COUNCIL ASSESSMENT REPORT – MODIFICATION APPLICATION

HUNTER AND CENTRAL COAST REGIONAL PLANNING PANEL

PANEL REFERENCE & DA NUMBER	PPSHCC-220–MA2023-00175 - PAN-330384
PROPOSAL	Sec 4.55(2) Modification to DA2017/00701 - Concept Development Application - Staged development comprising of retail, commercial, residential and shop top housing - change to design (building height)
ADDRESS	<p>Lot 31-32 DP 864001</p> <p>Lot A & B DP 388647</p> <p>Lot 1 DP 77846</p> <p>Lot 96, 98 & 100 DP 1098095</p> <p>Lot 1 & 2 DP331535</p> <p>Lot 1 DP 723967</p> <p>Lot 1 DP 819134</p> <p>105, 109, 111 & 121 Hunter St Newcastle</p> <p>3 Morgan St Newcastle</p> <p>22 Newcomen St Newcastle</p> <p>66-74 King St Newcastle</p>
APPLICANT	Urbis
OWNER	East End Stage 3 Pty Ltd & East End Stage 4 Pty Ltd
MOD LODGEMENT DATE	1 June 2023
ORIGINAL DA DETERMINATION DATE	2 January 2018
APPLICATION TYPE	Modification Application under Section 4.55(2)
REGIONALLY SIGNIFICANT CRITERIA	The proposal involves a s4.55(2) application which triggers consideration by the Hunter Central Coast Regional Planning Panel via the s275(2) directions under the <i>Environmental Planning & Assessment Regulation 2021</i> .

Figure 6 - Proposed Envelope/Height Plan Source Urbis

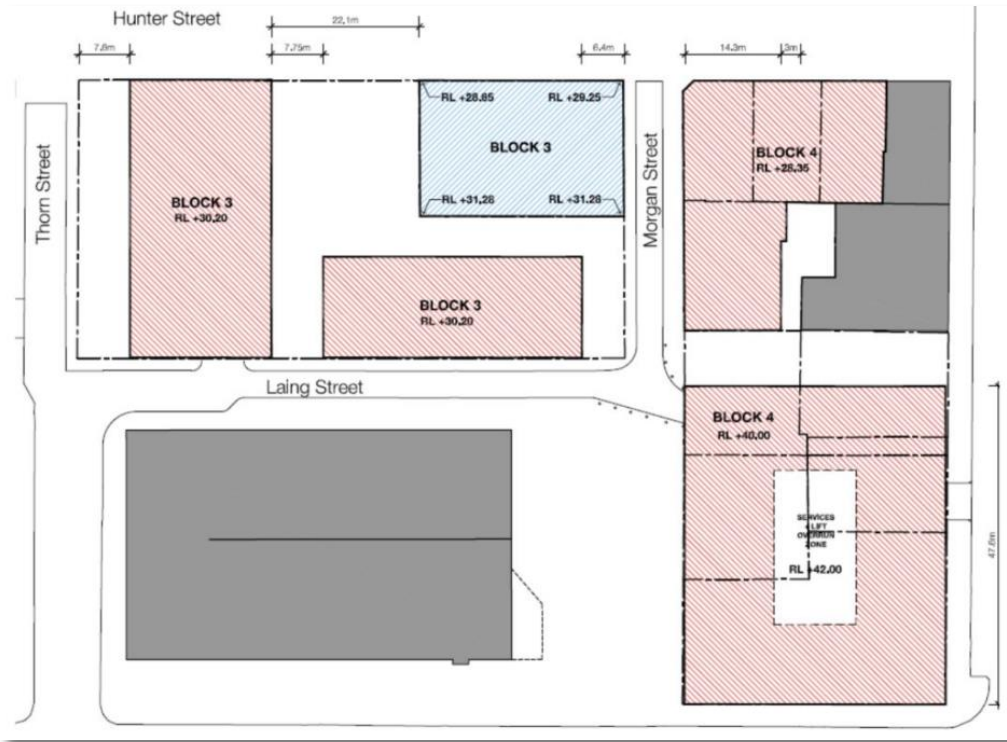
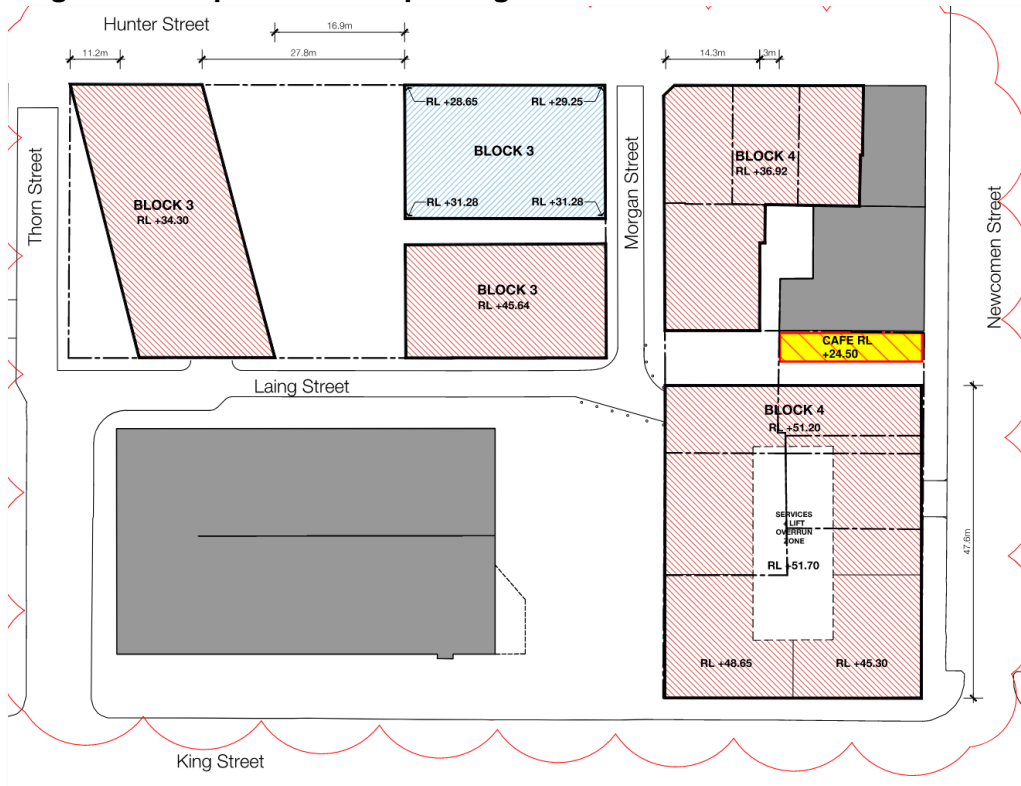
Figure 5 - Approved Concept DA 'Envelope/height plan' noting Building '3 South' within the view corridor from Hunter St Mall to Christ Church cathedral Source- Urbis

The proposed changes in the building height of the development has two interrelated aspects being; a) direct changes to the Concept DA heights, and b) the changes to where that height is proposed due to the modified envelope layout.

The proposed changes in the height and the layout of the building envelopes are to facilitate an improved view corridor from the harbour to Christ Church Cathedral (see **Figure 7** for a perspective of the intended outcome) and have arisen as a result for the Design Excellence Competition, in which CN identify the corridor as being of public interest.

In addition to the proposed increases in the allowable heights under the Concept DA, it is also proposed to alter the approved layout of the building envelopes to align with those proposed in DA2023/00419 and facilitate an improved view corridor from the harbour to Christ Church Cathedral as discussed above (see **Figure 5, 6 & 7**).

The proposed modification seeks to alter the allowable building height of the overall development under the Concept DA. It is noted that the existing allowable heights under the NLEP are also inconsistent with the approved Concept DA heights as the allowable envelopes do not align (see **Figure 5 & 6**).
